Office <u>District I</u> – (575) 393-6161	State of New Energy, Minerals and N		Form C-103 Revised July 18, 2013		
1625 N. French Dr., Hobbs, NM 88240 <u>District II</u> – (575) 748-1283			WELL API NO. 30-015-44538		
811 S. First St., Artesia, NM 88210	OIL CONSERVATION	NOISIVID NC			
District III - (505) 334-6178	1220 South St. F	Francis Dr.	5. Indicate Type of Lease STATE X FEE		
1000 Rio Brazos Rd., Aztec, NM 87410 <u>District IV</u> – (505) 476-3460	Santa Fe, NM	87505	6. State Oil & Gas Lease No.		
1220 S. St. Francis Dr., Santa Fe, NM					
87505 SUNDRY NOT	ICES AND REPORTS ON WEI	LS	7. Lease Name or Unit Agreement Name		
(DO NOT USE THIS FORM FOR PROPO DIFFERENT RESERVOIR. USE "APPL PROPOSALS.)	SALS TO DRILL OR TO DEEPEN OR	PLUG BACK TO A	DARK CANYON 15-22 STATE COM WCB

WELL LOCATION AND ACREAGE DEDICATION PLAT

Dark Canyon 15-22 State Com WCB 2H									
Pool Information	9	URPLE SAGE; WOLFCAMP							
Work Type	11	New Well							
Well Type	12	GAS							
Cable/Rotary	13	lotary							
Lease Type	14	tate							
Ground Elevation	15	3326							
Multiple	16	No	No						
Proposed Depth	17	16837'MD							
Formation	18	Wolfcamp	Volfcamp						
Contractor	19	Latshaw	atshaw						
Spud Date

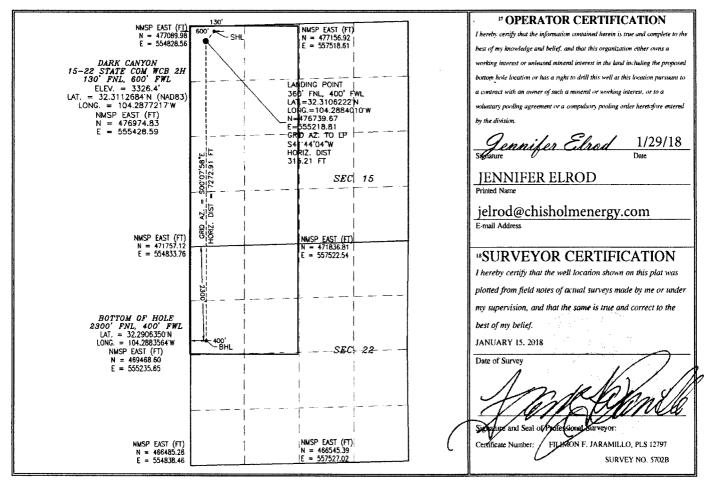
of starting any proposed w proposed completion or re CHANGE NAME FROM: DARK CANYON 22-15 S 32068 TO: DARK CANYON 15-22 STA CHANGE SURFACE LOCATION FROM: UL-M, SECT 22, 145 FSI TO: UL-D, SECT 15, 130 FNL, 60 CHANGE CASING PLANS SURFACE: SETTING DEPTH FROM: 400' / TO: 420' CMNT / 35/8" 48/40 FROM: 530 SXS / TO: 385 SXS	ork). SEE RULE 19.15.7.14 NM completion. 9/5 FATE WCA 2H TE COM WCB 2H 1060 FWL 0 FWL CHANGE PROPOSE FROM: 18610 MD TO: 16837 MD CHANGE BOTTOM FROM: UL-D, SECTOM UL-D, SECTOM UL-D, SECTOM UL-E, SECTOM SECTING DEPTH FROM: 52007 TO: 7 CMNT FROM: 2935 SXS /	MAC. For Multiple Conservation MINING HOLE LOCATION ET 15, 334 FNL, 430 FWL 2, 2300 FNL, 400 FWL CASING WEIGHT 6# TO: 2565 SXS	PRODUCTION: CASING MEGITIVED FROM: 17#/ TO: 20# SETTING DEPTH FROM: 18610/ TO: 16837' CMNT FROM: 3908 SXS/ TO: 2390 SXS TOC		
of starting any proposed we proposed completion or rechange name 3/9 FROM:DARK CANYON 22-15 S 32068 4-TO: DARK CANYON 15-22 STA CHANGE SURFACE LOCATION FROM: UL-M, SECT 22, 145 FSI TO: UL-D, SECT 15, 130 FNL, 60 CHANGE CASING PLANS SURFACE: SETTING DEPTIL FROM: 400' / TO: 420' CMNT / 35/8" 484	ork). SEE RULE 19.15.7.14 NM completion. 9/5 FATE WCA 2H TE COM WCB 2H 1060 FWL 0 FWL 1 TO: UL-D, SEC TO: UL-E, SECT 2 INTERMEDIATE: FROM: 40# / TO: 3 SETTING DEPTH FROM: 52009/ TO: 7 CMNT	MAC. For Multiple Conservation MINING HOLE LOCATION ET 15, 334 FNL, 430 FWL 2, 2300 FNL, 400 FWL CASING WEIGHT 6# TO: 2565 SXS	PRODUCTION: CASING MEGITIVED FROM: 17#/ TO: 20# SETTING DEPTH FROM: 18610/ TO: 16837' CMNT FROM: 3908 SXS/ TO: 2390 SXS TOC
